URGENT MEDICAL DEVICE CORRECTION

MAQUET CARDIOSAVE hybrid and MAQUET CARDIOSAVE rescue

Product Code/Part Number:	0998-XX-0800-XX
Distributed Affected Lot Number:	All
Distribution Dates:	Since March 6, 2012

Figure 1 – Monitor Display (1 – Helium Indicator)

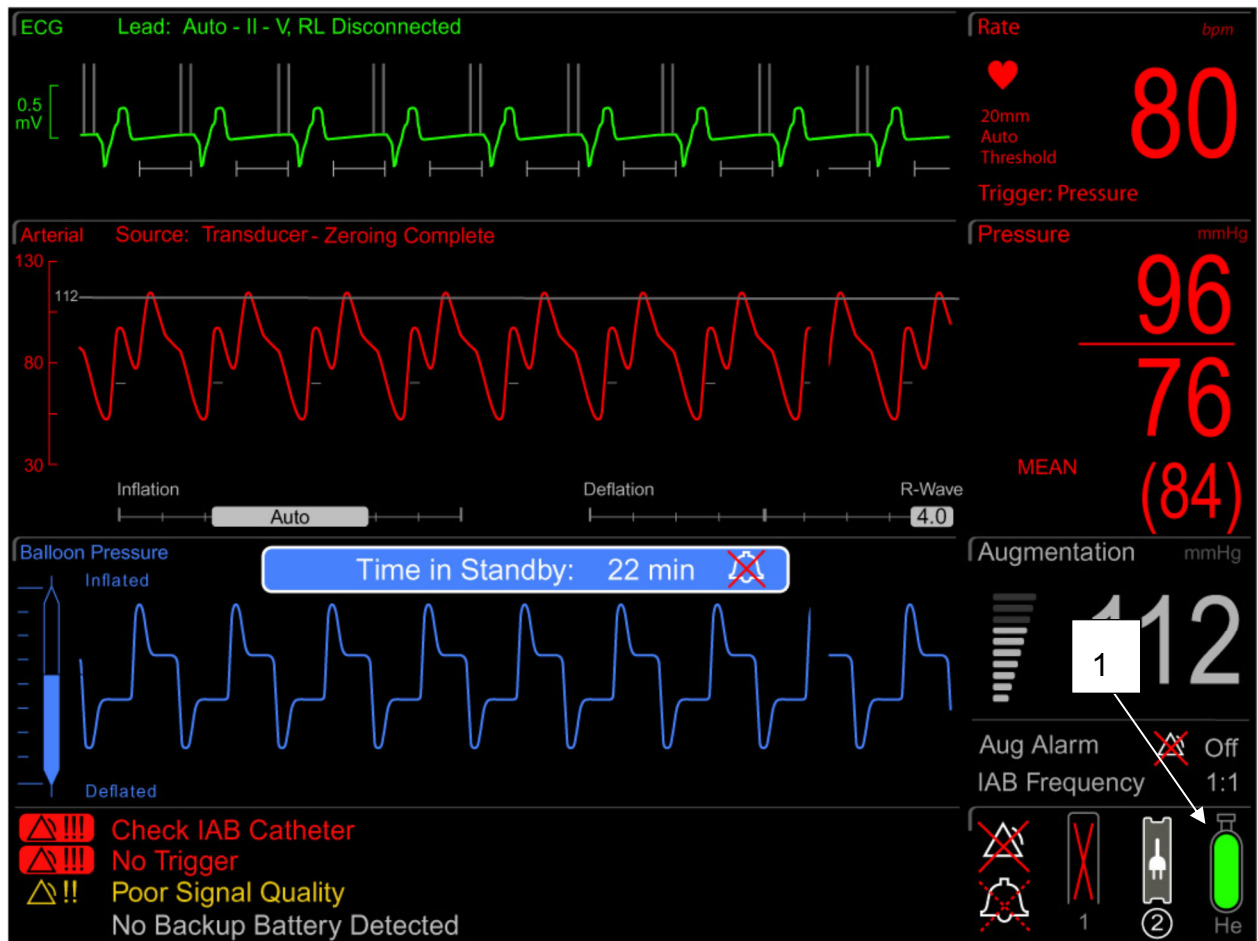
During Electromagnetic Compatibility (EMC) testing at an external lab, Getinge personnel determined that in the presence of some radiated RF disturbances, the Helium Indicator on the Cardiosave IABP (refer to Figure 1) would intermittently over-report the remaining Helium Capacity. Once the disturbance was removed the Helium indicator always fully recovered within 10 seconds to display the proper level without any over-reporting.

Getinge’s investigation revealed that the over-reporting of Helium Capacity would intermittently occur at frequency ranges between 80 MHz – 1 GHz. Potential sources of interference include: radio communication, cell phone, Wi Fi, RFID equipment and equipment that does not meet current electromagnetic compatibility standards.

Issue 1: Immediate Actions to be taken now:

Users should perform the following actions to limit the possibility of loss of therapy due to an over-reporting of remaining helium on the Helium Indicator.

Figure 2 – Top Panel (1 – Mechanical Helium Gauge)

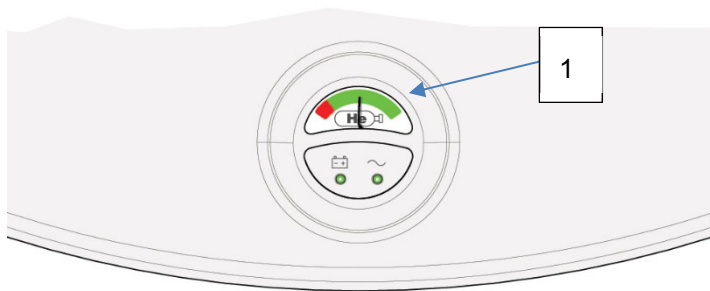
Since the mechanical gauge is not influenced by EMC, view the mechanical gauge on the Cardiosave Top Panel (See figure 2) to assess remaining helium capacity in case of suspected EMC disturbances.
